Council Agenda Report

City Council Meeting
05-20-26
Item 1.A

Subject: Appeal of Planning Commission Resolution No. 25-02 Regarding Coastal Development Permit No. 22-009 (24515 Vantage Point Terrace, APN 4458-033-005; Owner, 24515 Vantage Point Syndication LLC; Appellant, Alistair Saeghi)

Figure 2 – Original and Revised Roof Deck

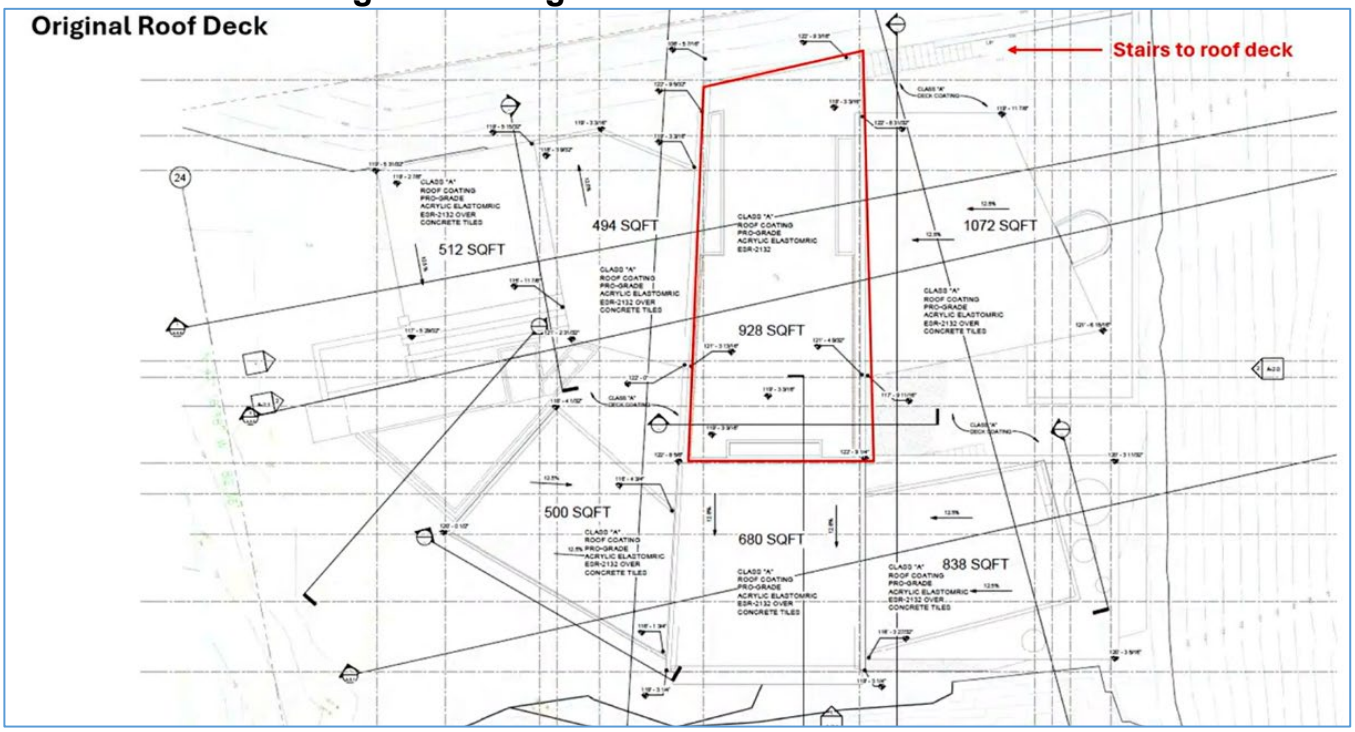
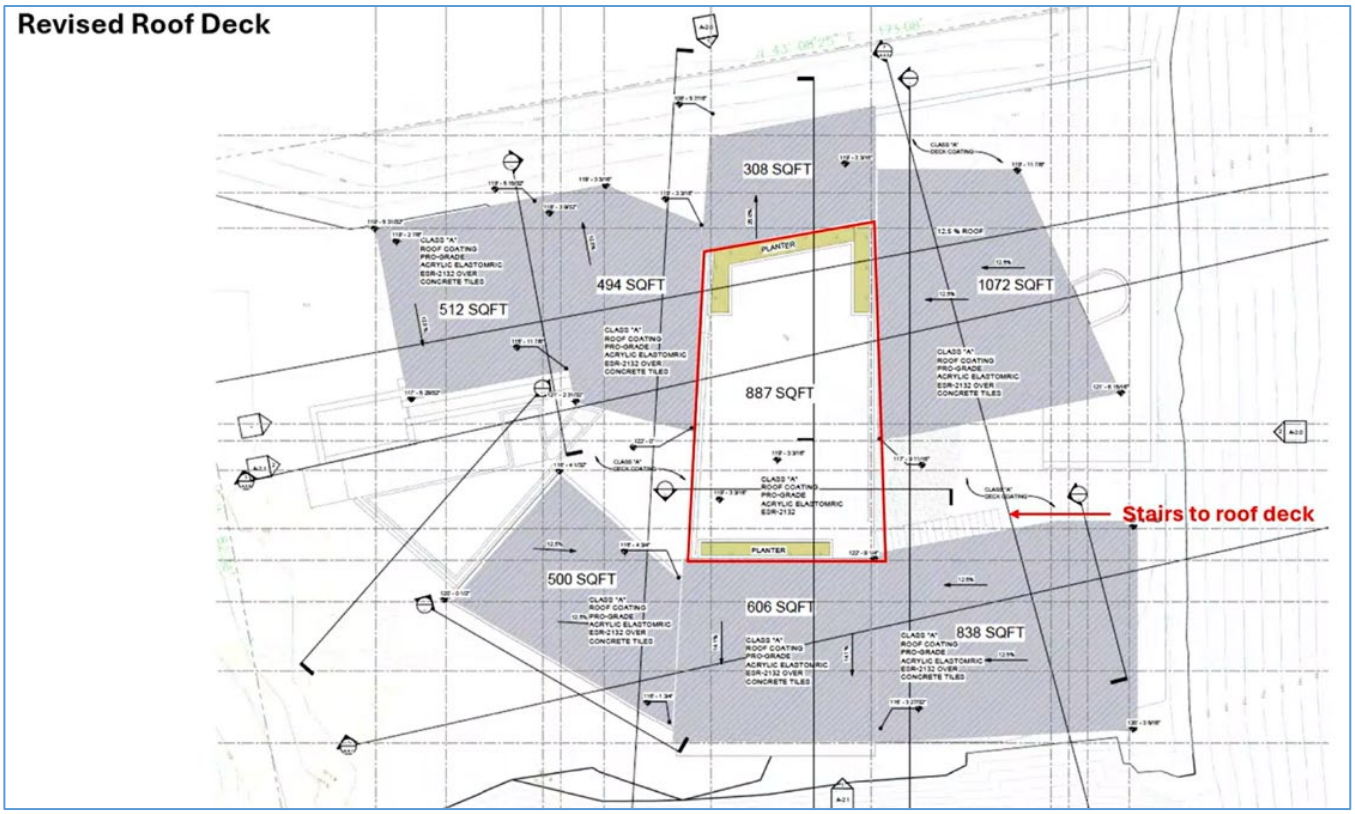
Appeal Item 1. Roof deck is out of scale and oversized. The appellant states that the proposed roof deck would be completely out of scale and character with developments in the vicinity. The appellant claims its size and design directly threaten the privacy of surrounding properties and asserts that the roof deck would create intrusive viewing angles into the appellant's home. The appellant states that the Planning Division failed to analyze surrounding properties and to inventory sizes of roof decks in the MCE Overlay. The appellant claims that the review and approval of the CDP defy the objectives of the MCE Overlay, the General Plan, and the Code.

Between October 2024 and March 2025, the roof deck was redesigned to address concerns raised by the appellant and address potentially intrusive viewing angles into the appellant's property. A summary of the revisions made are described above in the Project Background section. These revisions were designed to preserve privacy and minimize intrusive angles between the proposed roof deck and the appellant's residence. As approved, the Planning Commission found the redesigned roof deck to be sufficient in addressing privacy concerns.

The LCP and MMC do not state specific development standards regarding the maximum size, shape, or orientation of a roof deck. Instead, roof decks are required to meet typical building design standards such as overall height and setbacks of the primary structure to which it's attached. The MCE Overlay District, however, does provide specific design criteria for flat roofs, which are limited to a maximum of 20 percent of total roof area, pursuant to LCP Local Implementation Plan (LIP) Section 3.4.1(D)(10). The proposed residence primarily features a pitched roof (which is defined as steeper than 8:1), with the exception of the roof deck, which is flat. The redesigned 887 square foot roof deck represents 17.0 percent of the total roof area (5,217 square feet), and complies with the 20 percent limitation[1]. Calculations determining the percent of flat roof area are derived from Figure 2 below, which shows the original and revised roof deck configuration. The appellant also does not cite any specific provision of the LIP or MMC to which the deck would not conform.

Figure 1 – Original Roof Plan

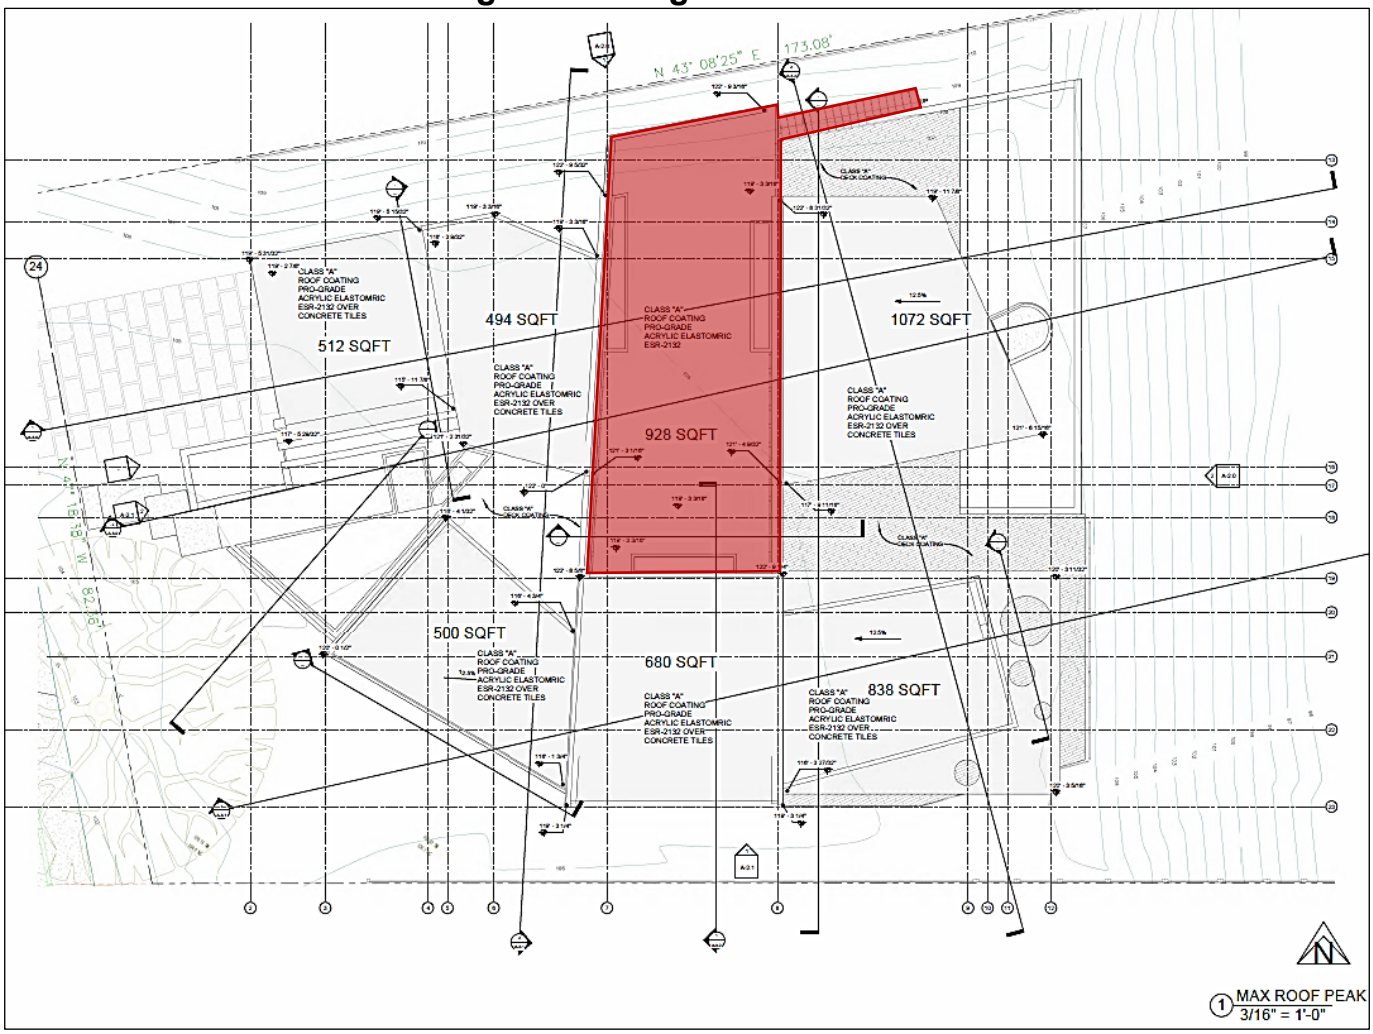
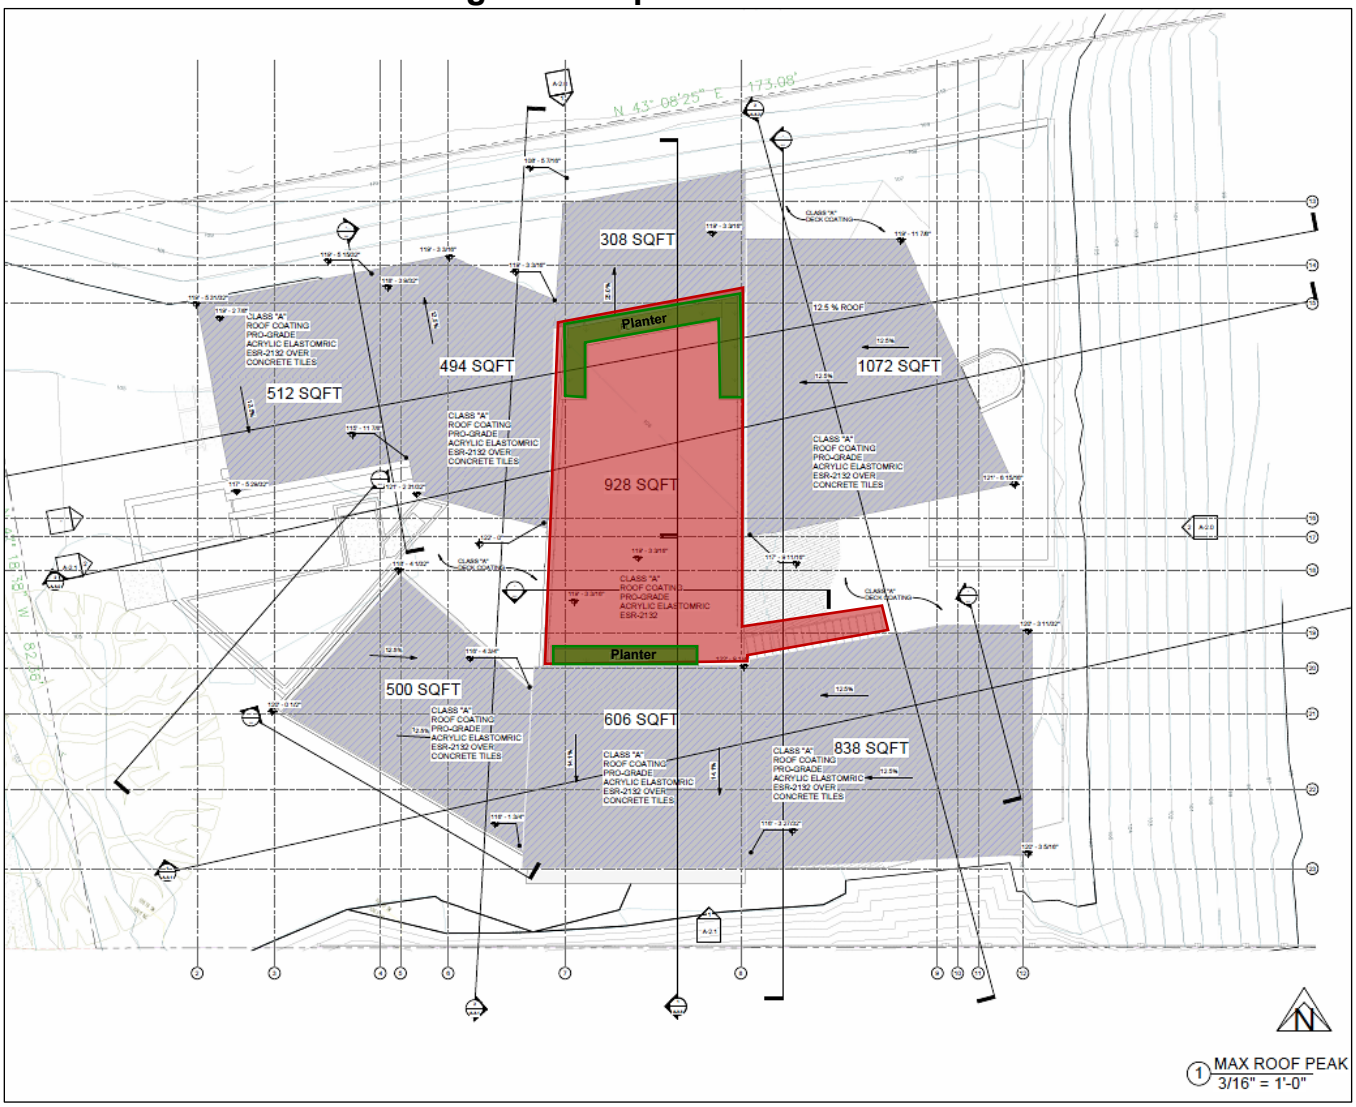
above, the original and modified roof comply with this requirement. Although there are no development standards that specifically prohibit the invasion of privacy from proposed development there are references in the General Plan and MMC that encourage new public recreation facilities and the thinning and/or removal of landscaping to consider the privacy concerns for private property owners. Because the proposed project included a portion of the roof deck with exterior stair access that would potentially invade the concerned neighbor's privacy located north of the project site, the project has been modified to address privacy concerns.

NORTH	DATE	PROJ. #	SCALE	DRAWING
	10/21/24 12:51 PM	19-2018	1/8" = 1'-0"	A-0.1
	DRAWN	CAD BY	FLOOR	
	Author	Designer

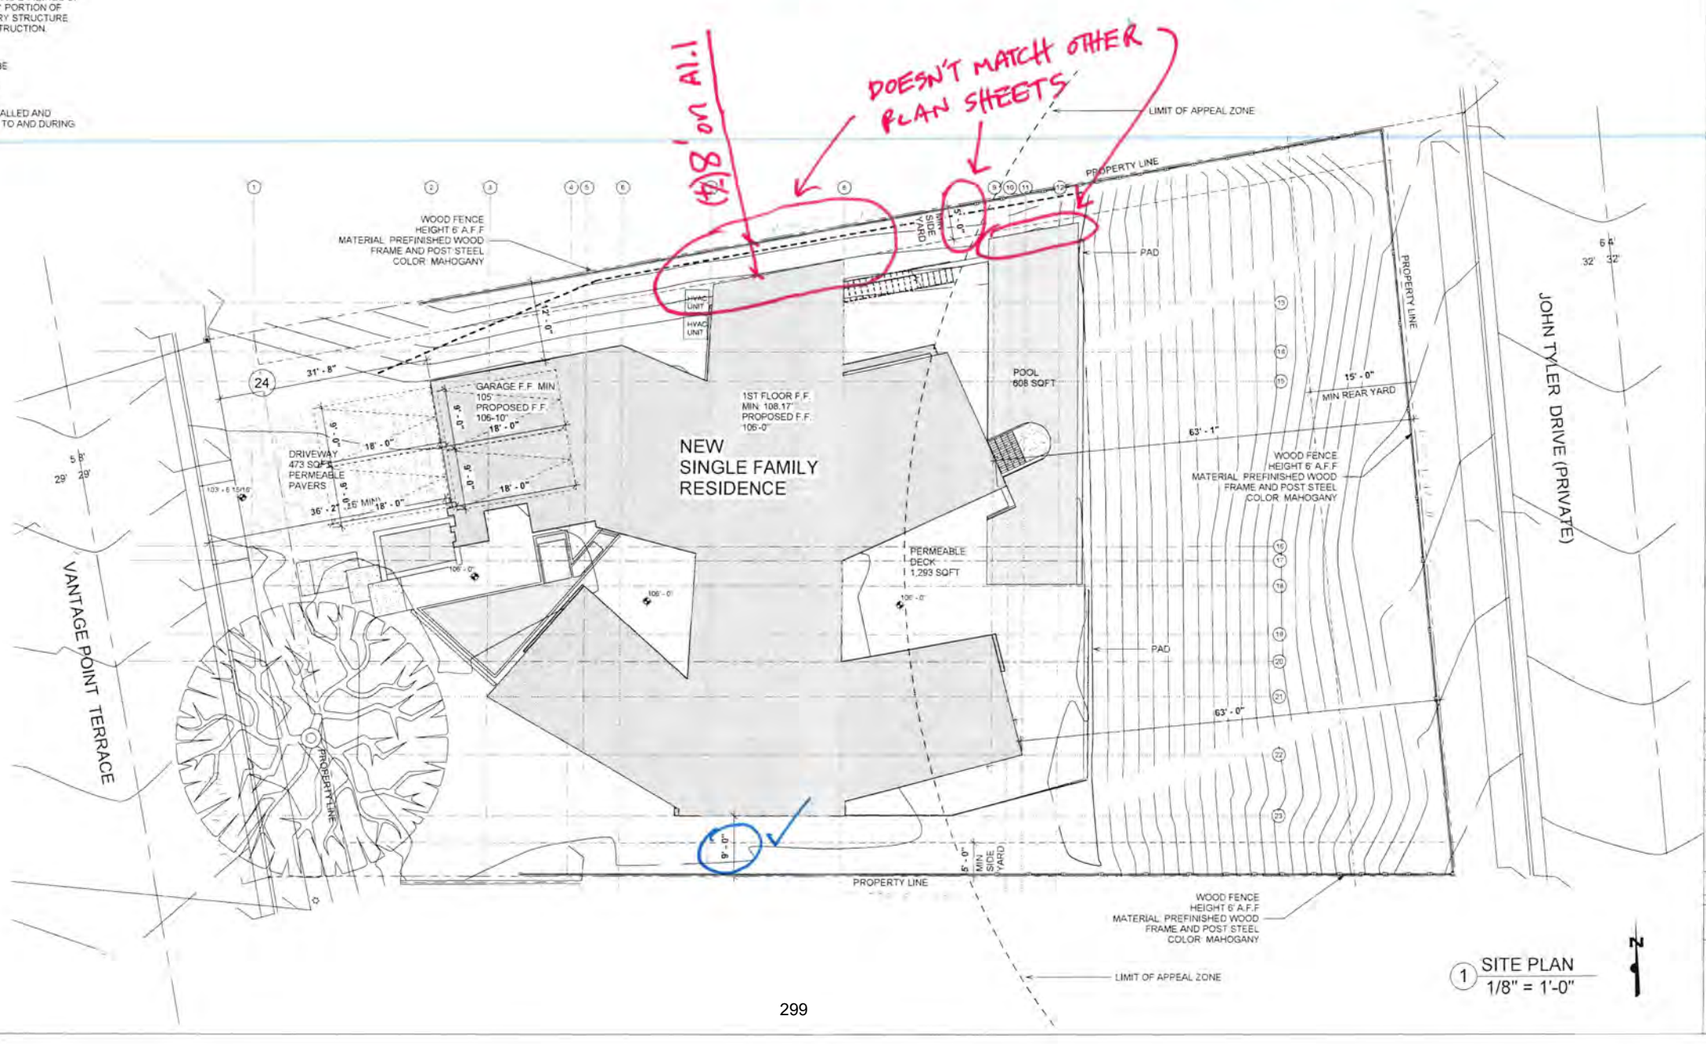
THIS PLAN SHOWS 5' SETBACK TO DINING ROOM & POOL, BUT OTHER SHEETS DEPICT (+/-) 8' SETBACK

line of at least 8 feet at all locations. The 8-foot setback exceeds the minimum requirement of 5 feet by 60%. (Note: The zoning conformance table within the corresponding agenda report (Exhibit D), incorrectly labelled this proposed setback as 5 feet (the minimum required), rather than the proposed 8 feet depicted on the plans.)

NORTH	DATE	PROJ NO	SCALE	DRAWING
	10/2/2019 3:39:38 PM	18-0018	1" = 10'-0"	C-0.1
	DRAWN	CKD BY	FLOOR	
	Author	Designer

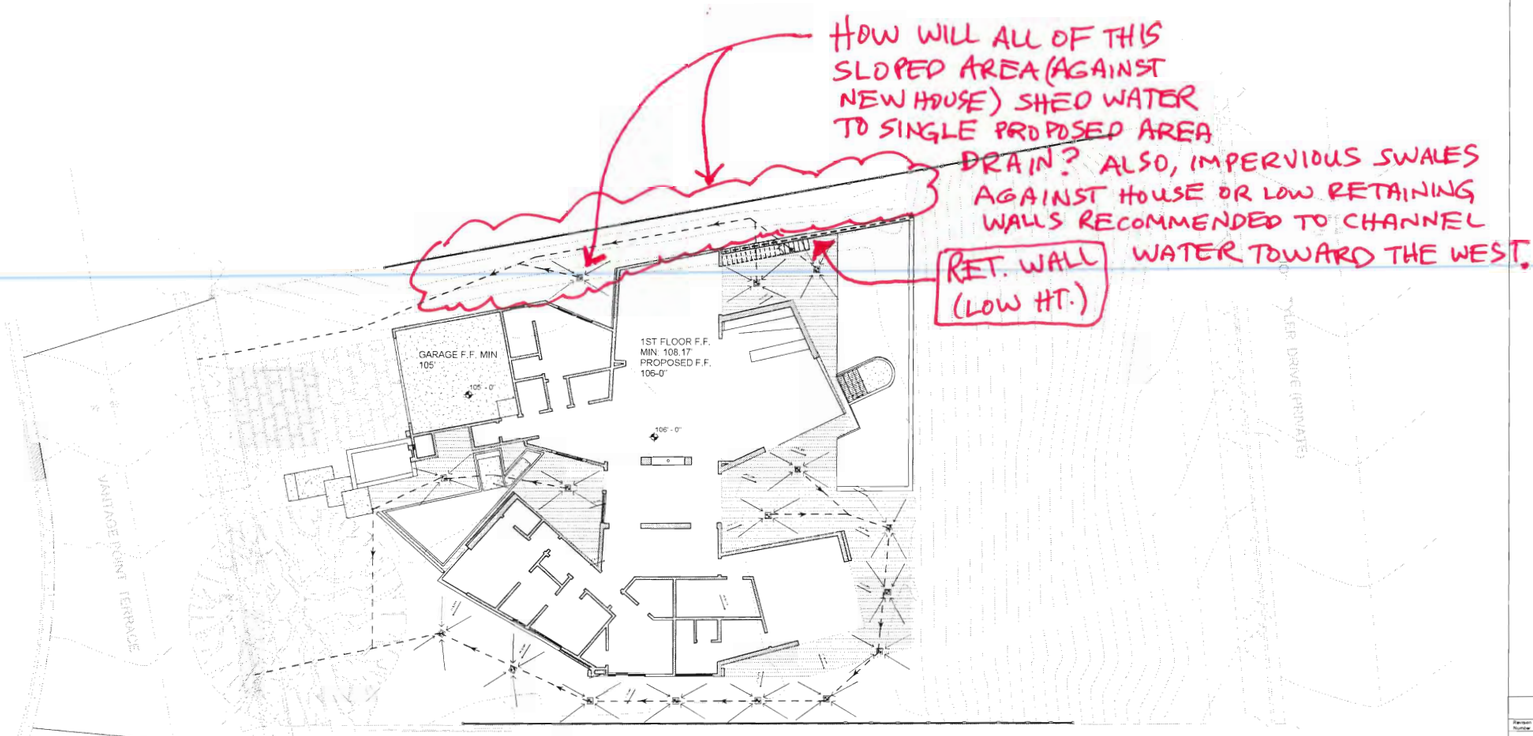
NO PROPOSED CHANGE TO THE BUILDING PAD

NORTH	DATE	PROJ.NO	SCALE	DRAWING
	10/20/23 1:36:16 PM	19-0018	1" = 10'-0"	
	DRAWN	CKD.BY	FLOOR	C-0.2
	Author	Designer

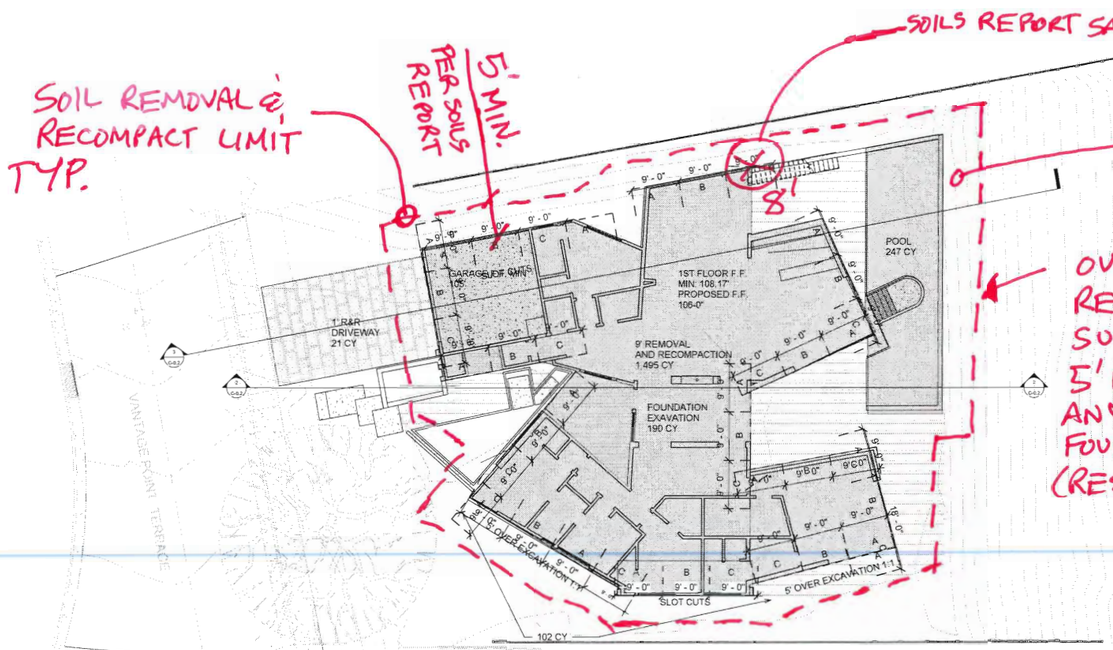
SOILS REPORT SAYS 8' MAX SLOT WIDTH

P~~A0-1~~ CORRECT POOL
A-0.1

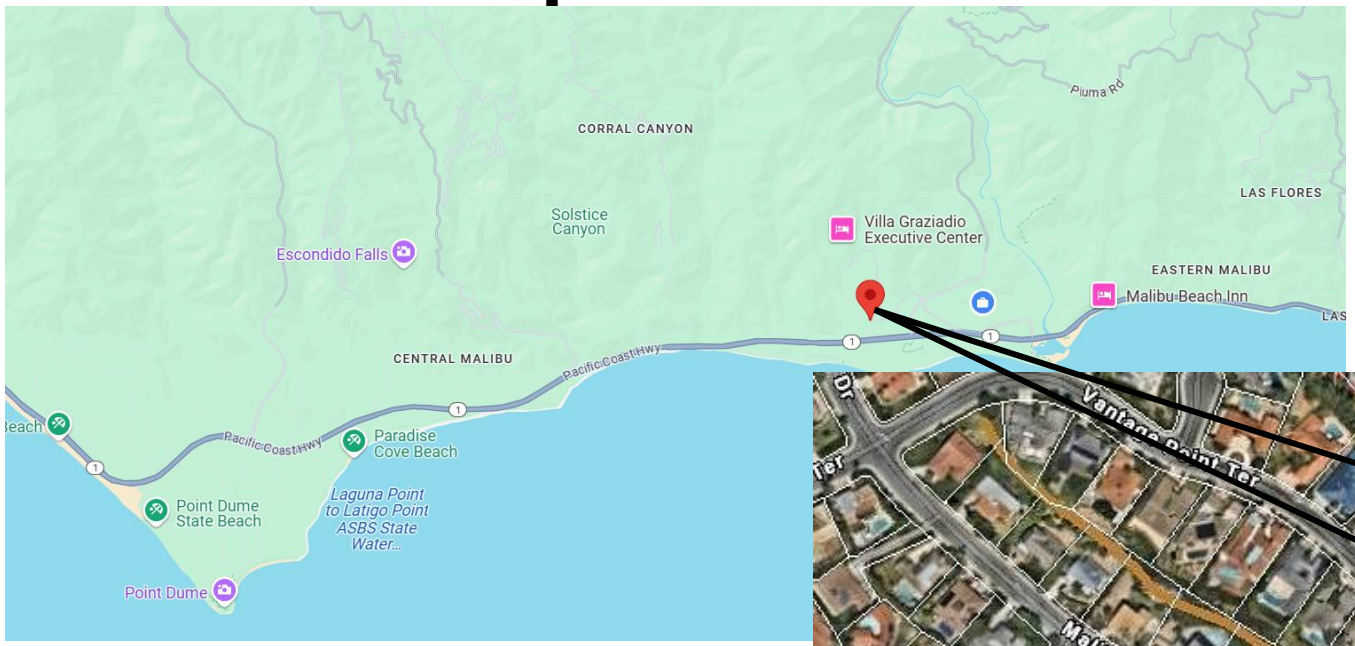
Coments:
[] **Sheet A-0.1** Pool is shown as projecting downslope from the edge of the established Pad for a blip shaped area for approximately 2' outward and about 22' in length.
[] **Sheet A-1.1** The pool seems to have a top of water elevation of a few inches below the apparent floor elevation of 105-10 ½". The edge of pad elevation is defined as 107'. Since the manufactured pad may not be extended … I don't understand how this works. No pool curb is depicted in either the Plan view or in the Sections?
[] **Sheet A-3.0** The blue hatching representing the water in the pool is incorrectly shown as beyond the allowable existing pad.
[] **Sheets A-3.1** and **A-3.**2 depict earth on top of the building slab and in the building?

A-3.0 POOL POCHE BLUE HATCH
'SLIPPED' FIX
HAZD LINES SEEM TO
BE IN COMPLIANCE
